Technical Service Information

THM 4T60-E NO FORWARD OR REVERSE

Figure 2

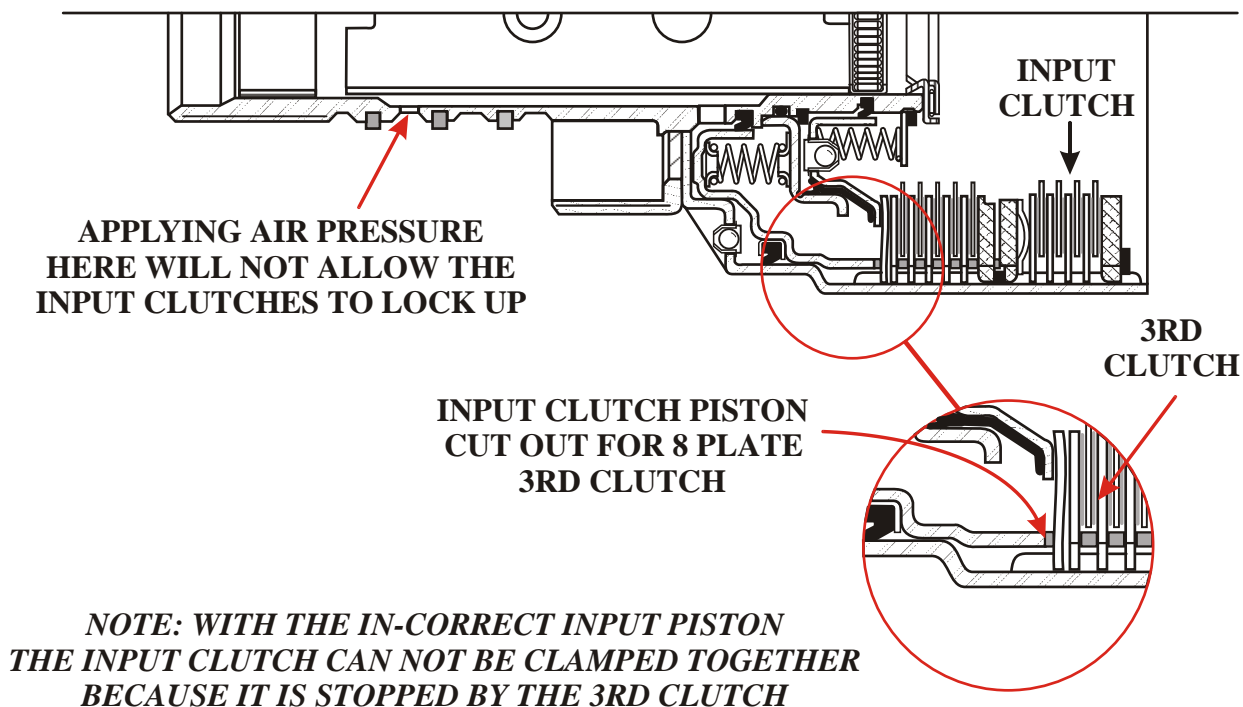
CAUSE: The cause may be, during overhaul, the input piston, which has a cut out that requires 10 3rd clutch plates, was replaced with a previous design 4T60 input piston that requires 8 3rd clutch plates. This mis-assembly stops the input piston from completely clamping the input clutch together, as shown in Figure 2, causing no Forward or Reverse engagement.

"CORRECT" INPUT DRUM ASSEMBLY

"IN-CORRECT" INPUT DRUM ASSEMBLY

CORRECTION: Refer to Figure 1 to identify the 4T60-E input piston. Refer to Figure 2 and locate the hole in the input drum to air check the input clutch to verify proper operation before final assembly.
